TOWN OF BROOKLINE

PURCHASE ORDER CHANGE FORM

FOR: Brookline High School - Third Floor and Quad Renovations

CHANGE ORDER NUMBER: 006
DATE: 11/03/2022
ARCHITECT'S PROJECT NO.:
CONTRACT DATE: March 29, 2022
CONTRACT FOR: 3rd Floor Renovation & Quad Repairs

DRAWING NUMBER:
A204

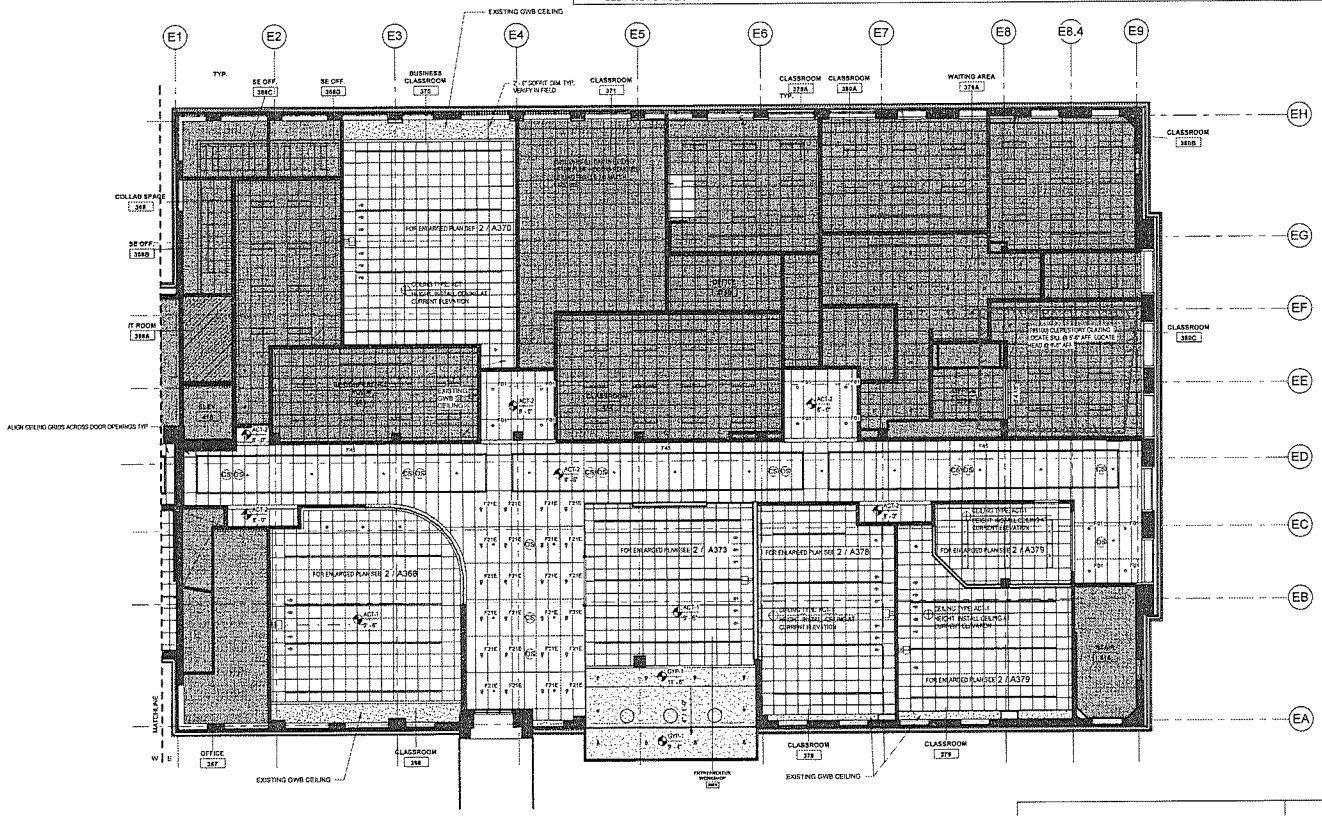
Please clarify if clerestory glass in room 380C is needed, per attached dwg A204.
Note:
This Item only appears in Permit Set drawing A204 (dated 03/30/2022) and not in the bid documents, per Kapiloff's Glass.

6/20/22
Per response and per drawings, window head shows to be installed @ 9'-6" AFF.
Please be informed that Office 377B has an existing ceiling height of 9'-0" AFF.
Please advise or/and provide design of opening with head height, sill height, dimensions, etc.

Please provide an ASI explaining the design intent (framing, divided lights ect...) and product type desired at this location. This will allow KGI to understand the size, number of pieces, glazing type as well as the logistics involved, so that we can provide you with a change order for this work.

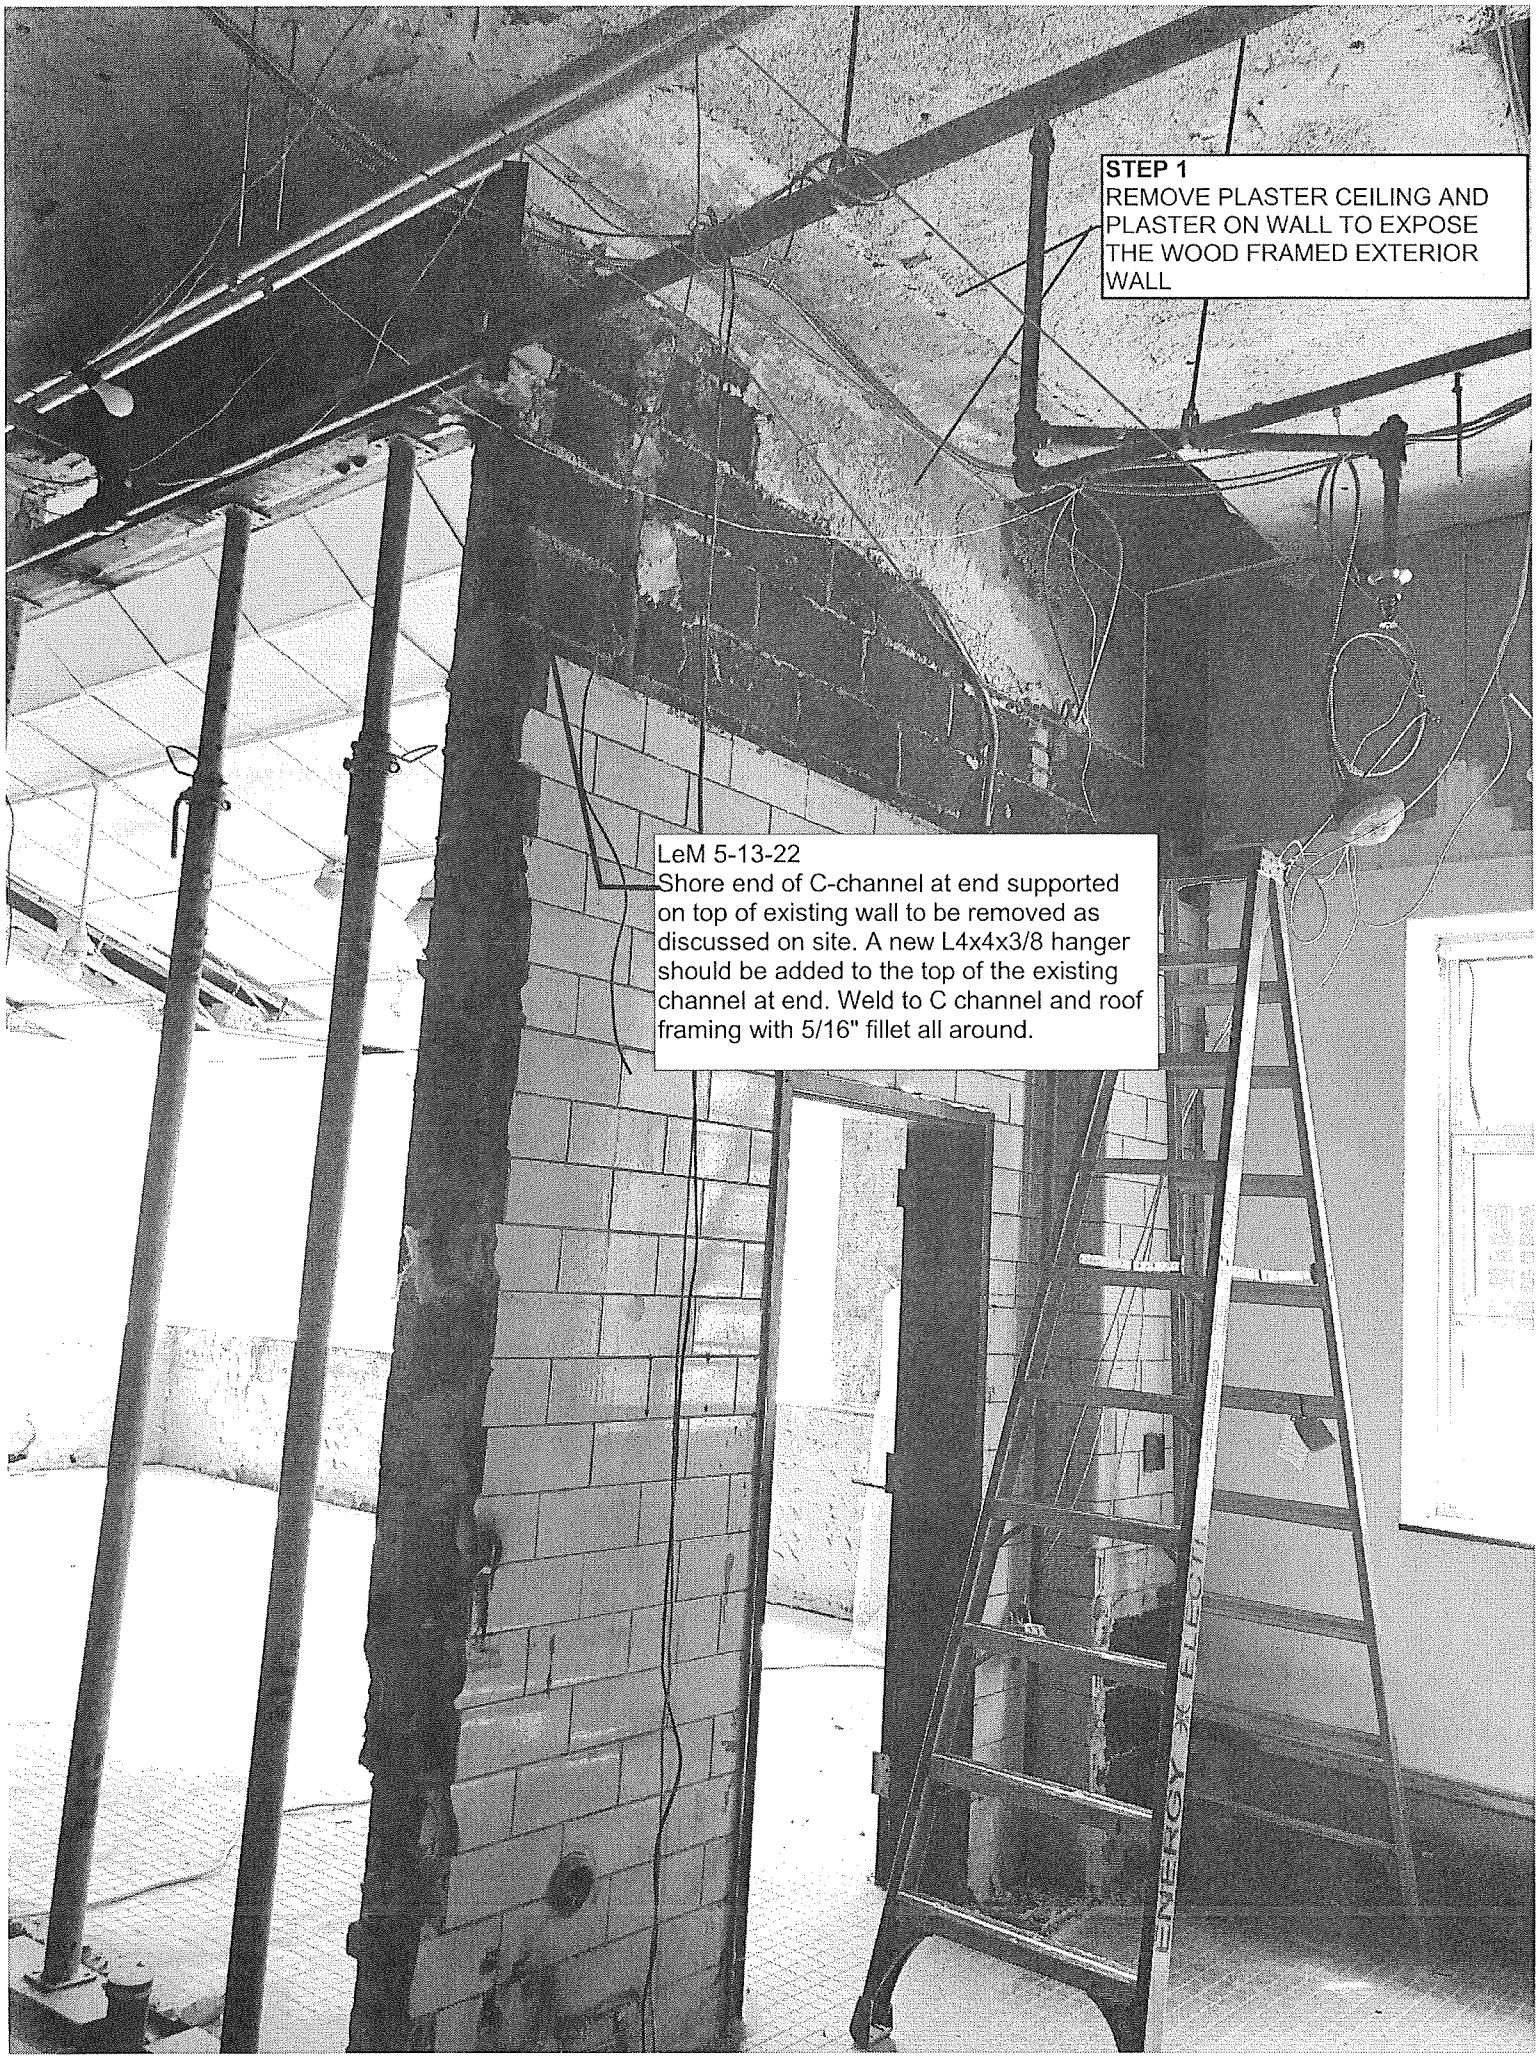
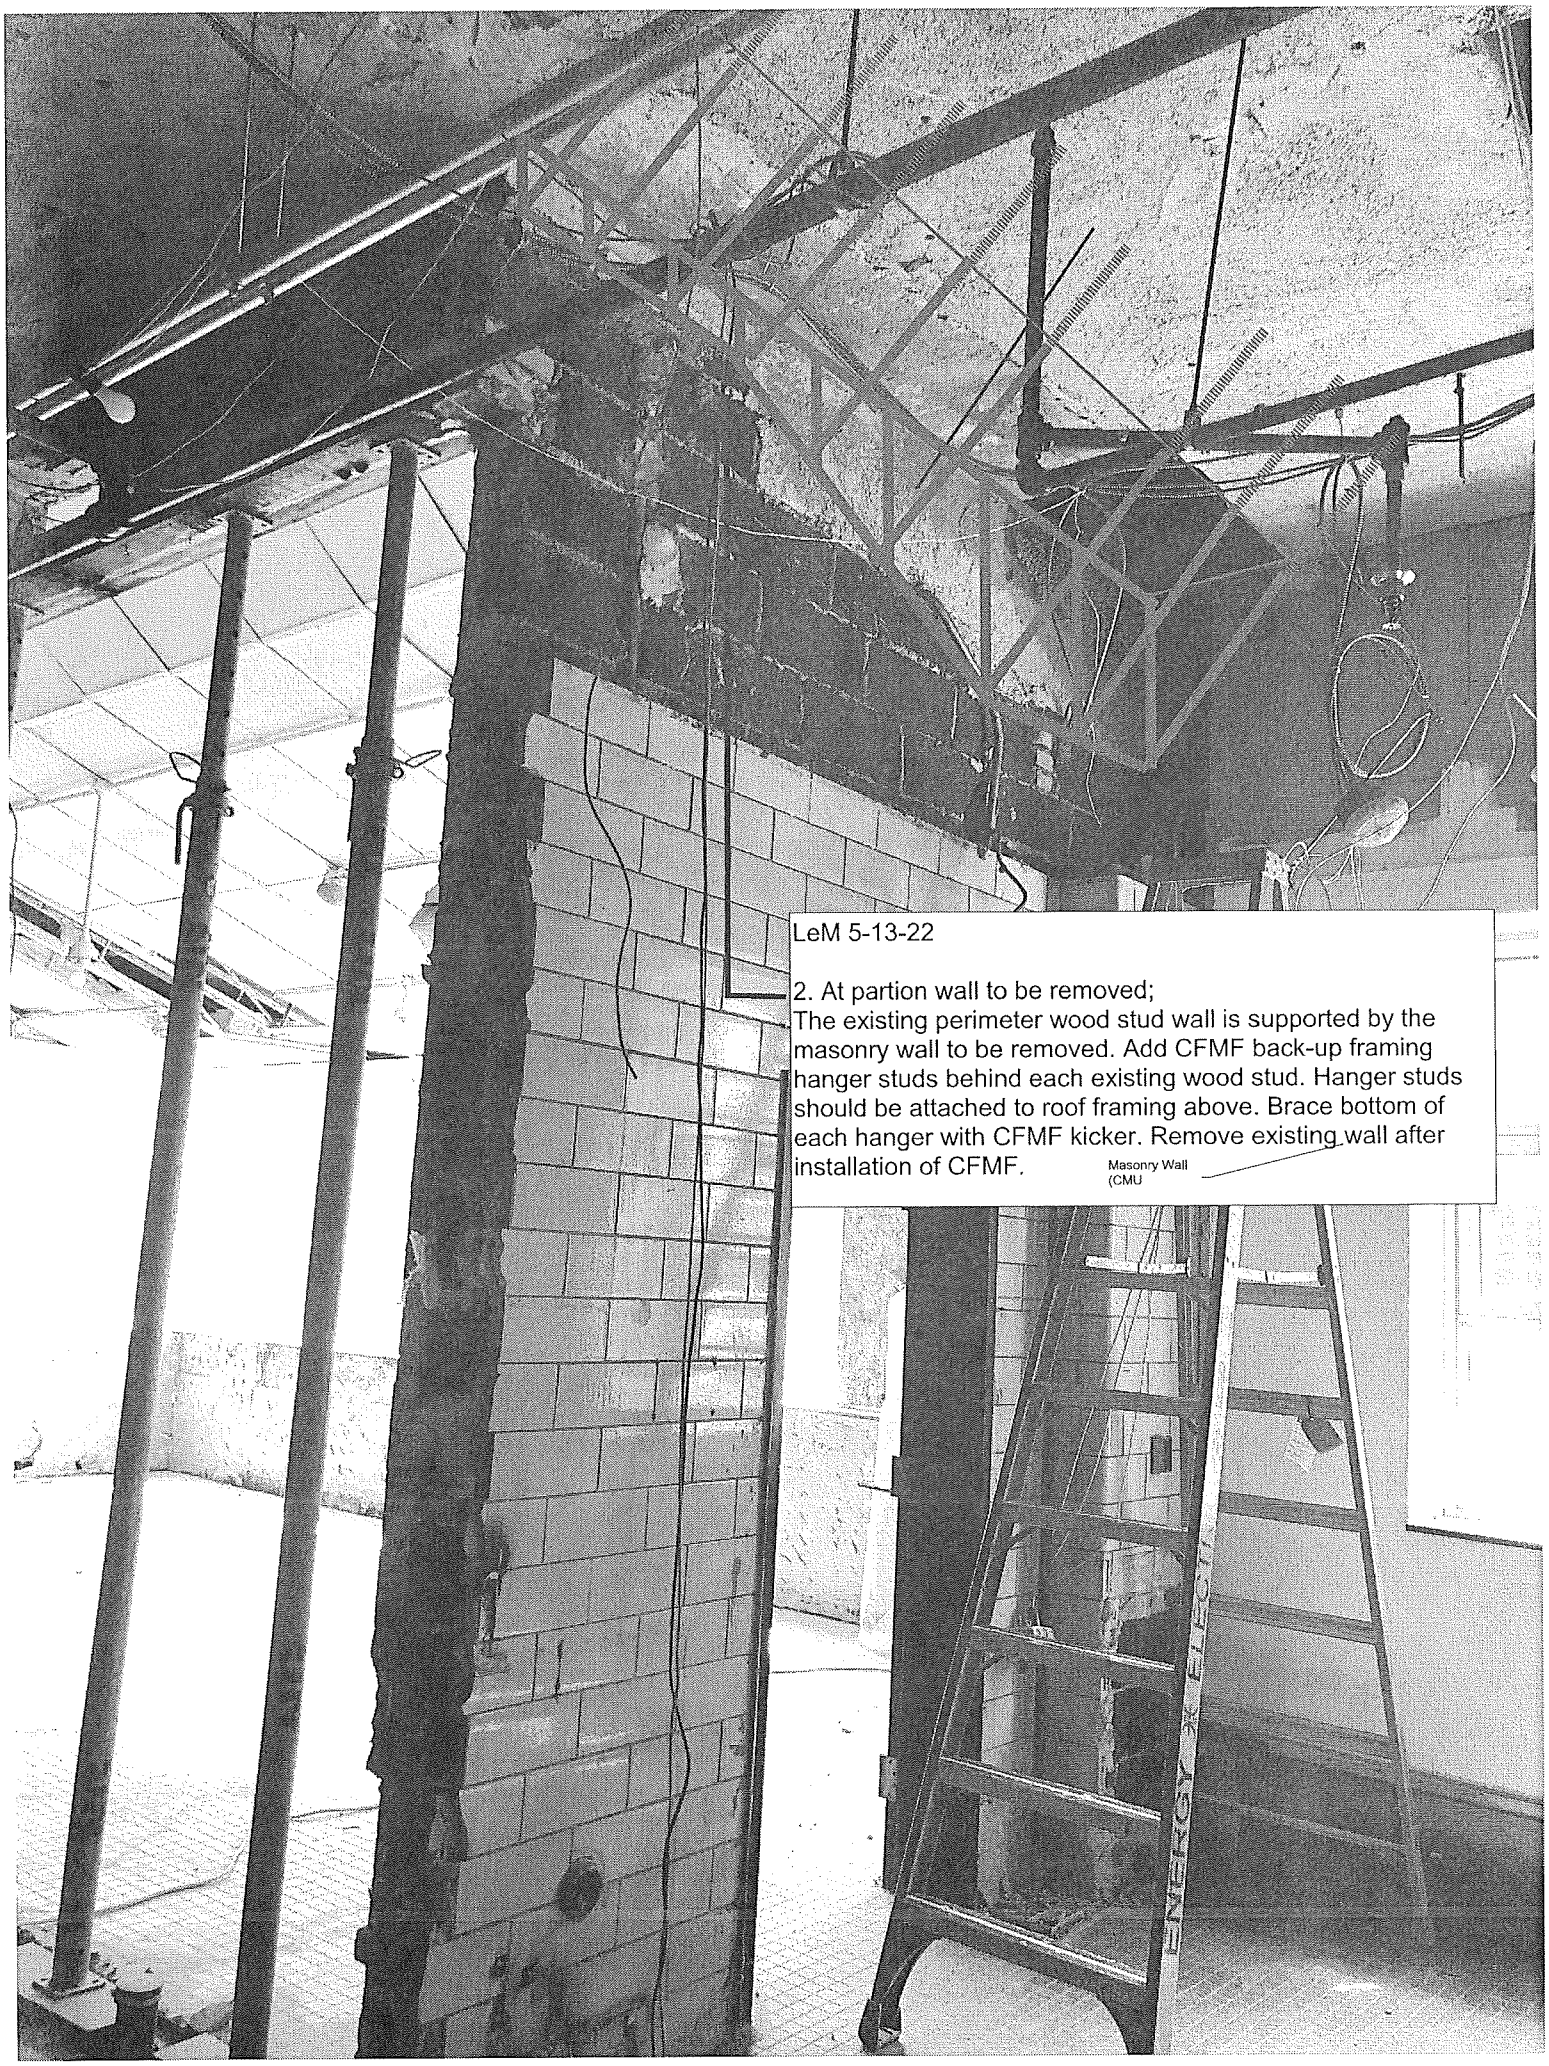
WRA Response: See comments on the attached photos. WRA comments are in blue and yellow.
- Andy Jonic
5/13/22

STEP 1
REMOVE PLASTER CEILING AND PLASTER ON WALL TO EXPOSE THE WOOD FRAMED EXTERIOR WALL
LeM 5-13-22
Shore end of C-channel at end supported on top of existing wall to be removed as discussed on site. A new L4x4x3/8 hanger should be added to the top of the existing channel at end. Weld to C channel and roof framing with 5/16" fillet all around.

LeM 5-13-22
2. At partion wall to be removed;
The existing perimeter wood stud wall is supported by the masonry wall to be removed. Add CFMF back-up framing hanger studs behind each existing wood stud. Hanger studs should be attached to roof framing above. Brace bottom of each hanger with CFMF kicker. Remove existing wall after installation of CFMF.
Masonry Wall (CMU

Remove CMU Wall & door frame per contract documents
